Sunwater Limited
Paradise Dam Safety Improvement Project
Technical Review Panel Report No 2

Technical Review Panel

Date **23 September 2019**
Status **Final**

Photo 2.5: Borehole PD-01: Moderately to strongly healed meta breccia. Fractures are healed with silica veinlets.

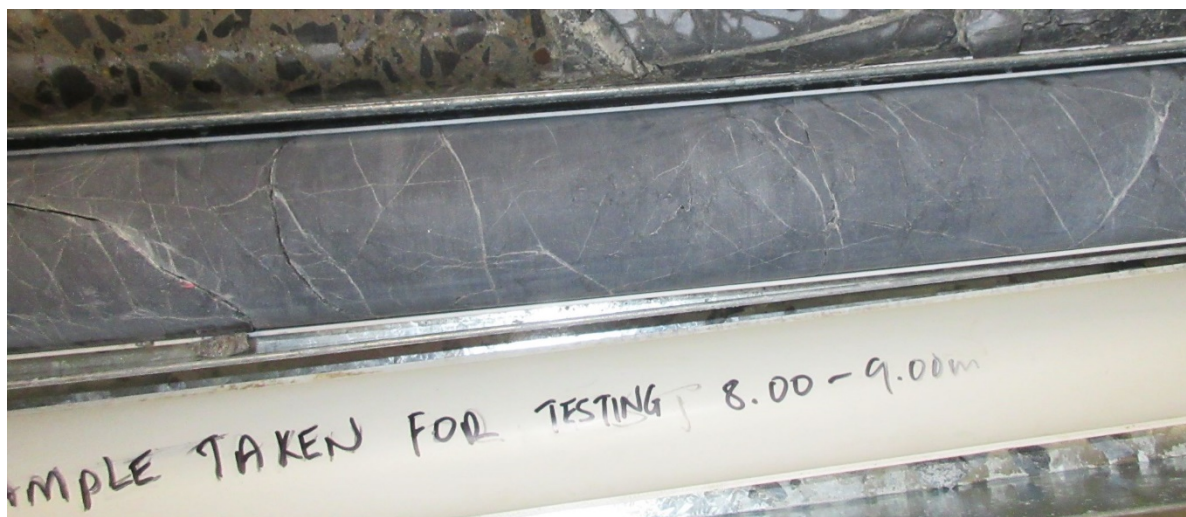
- c. **Strongly healed broken rock:** Photo 2.5 shows a healed fractured rock that is held together by strong silica veinlets. Generally, this category of rock can be tested by conventional unconfined compressive strength tests. Strongly bonded veinlets should not be counted as fractures when doing RQD assessments.

Fig 1 Stability Summary

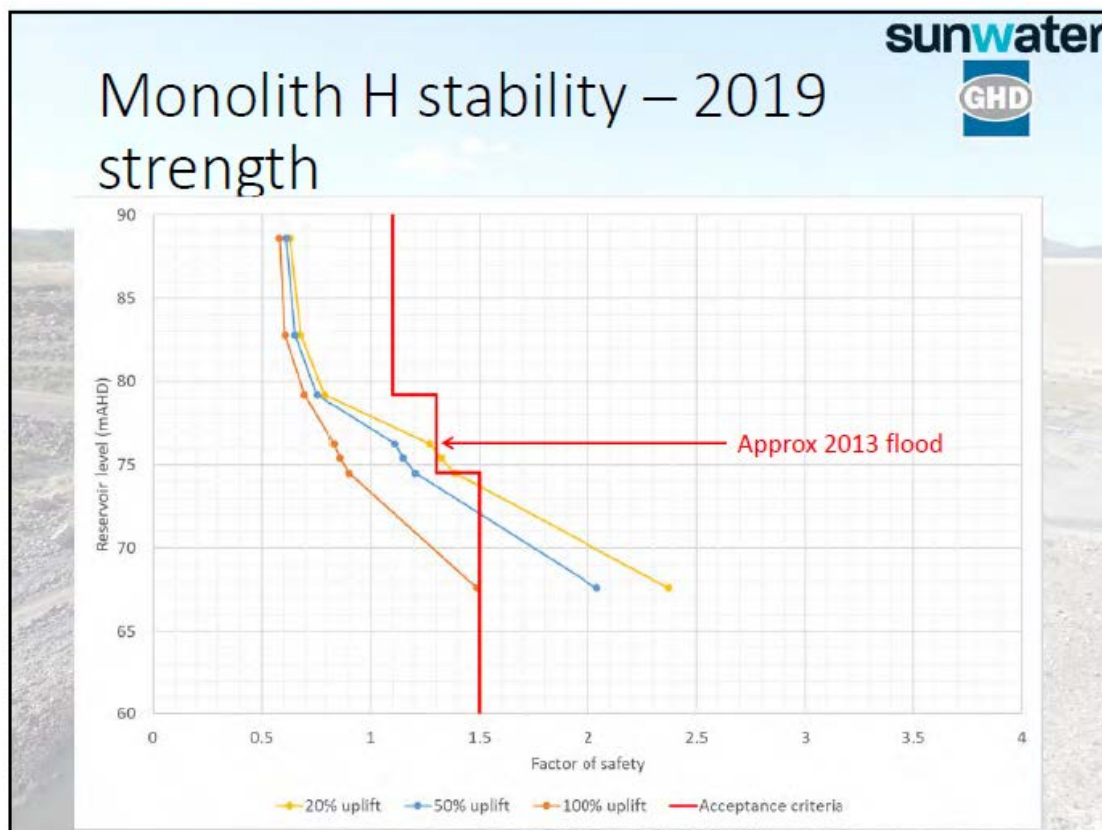
On the basis of GHD’s analysis results using the frictional strength of 39.3° presented in Fig 1 above the TRP notes:

- a) At FSL the stability meets ANCOLD criteria with uplift in the range of 50 to 70%.

- b) At the 1 in 50 AEP flood (EL 74.5 m) with uplift in the range of 50 to 100% the ANCOLD stability criteria for a usual load is not met
- c) At the 1 in 100 AEP flood (EL 75.4m) with 50 to 100 % uplift the ANCOLD criteria for an unusual load is not met
- d) At the 1 in 2000 AEP flood (EL 79.2 m) and beyond the ANCOLD criteria for an extreme load is not met.

At the 1 in 2000 AEP flood the friction would need to increase from 39.3° to approximately 50° to give a FOS of 1.1. Prior to the Canadian Guidelines (2007) and ANCOLD Guidelines (2011) the FERC and Canadian Guidelines required a FOS of 1.3, which would necessitate a friction angle of approximately 55°.

The TRP requests that the extent of any base cracking that occurs in the above analysis is also noted in the stability output, along with the normal stress at the downstream toe.
